Access Compliance Report Public Rights-of-Way (Curb Ramps)

Main Street: KENSINGTON_RD Cross Street: PIEDMONT_AVE Location: E

ADA ID: RPAT211206110258 Ramp Type: Type 1 - Perpendicular Diagonal Initial Pass/Fail: Fail Overall Compliance: No Severity Score: 19

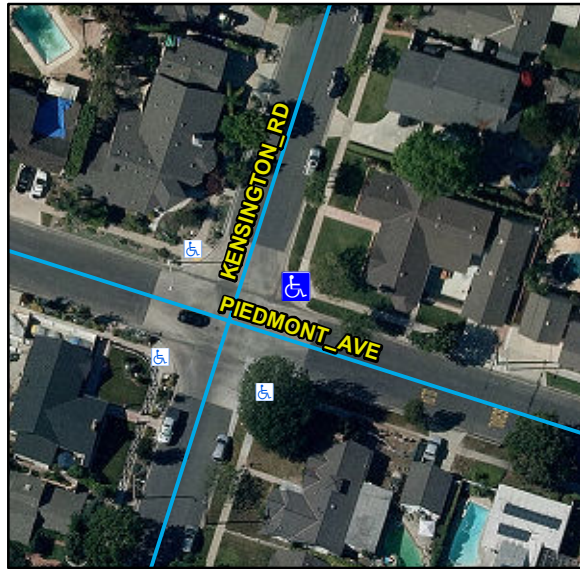
R304.2.2, R204.3, R304.5.1, STD 1115

Compliance	Description	Data	Compliance	Description	Data
N/A	Ramp Length (in)	83	N/A	Flare Type LT	
No	Ramp Width (in)	47			N/A
No	Ramp Run Slope (%)	9.4	N/A	Flare Slope LT (%)	N/A
Yes	Ramp Cross Slope (%)	0.2	N/A	Flare Traversable LT	N/A
N/A	Landing Present	N/A	N/A	Flare Type RT	
N/A	Landing Length (in)	N/A			N/A
N/A	Landing Width (in)	N/A	N/A	Flare Slope RT (%)	N/A
N/A	Landing Run Slope (%)	N/A	N/A	Flare Traversable RT	N/A
N/A	Landing Cross Slope (%)	N/A	N/A	DWS Provided	N/A
N/A	Landing Movement Obstructed?	N/A	N/A	DWS Contrast	N/A
	Landing Movement Type	N/A	N/A	DWS Length (in)	N/A
N/A	Landing Shared	N/A	N/A	DWS Full Width	N/A
N/A	Clear Space	Yes	N/A	DWS Offset Left (in)	N/A
N/A	Clear Space To Crosswalk (in)	N/A	N/A	DWS Offset Right (in)	N/A
N/A	Marked Crosswalk 1	No	N/A	Marked Crosswalk 2	No
	Crossing 1 Direction	NW		Crossing 2 Direction	SW
	Marked Crosswalk 1 Width (in)	N/A		Marked Crosswalk 2 Width (in)	N/A

Remove & Replace Curb Ramp With Two New Directional Ramps or Equivalent.
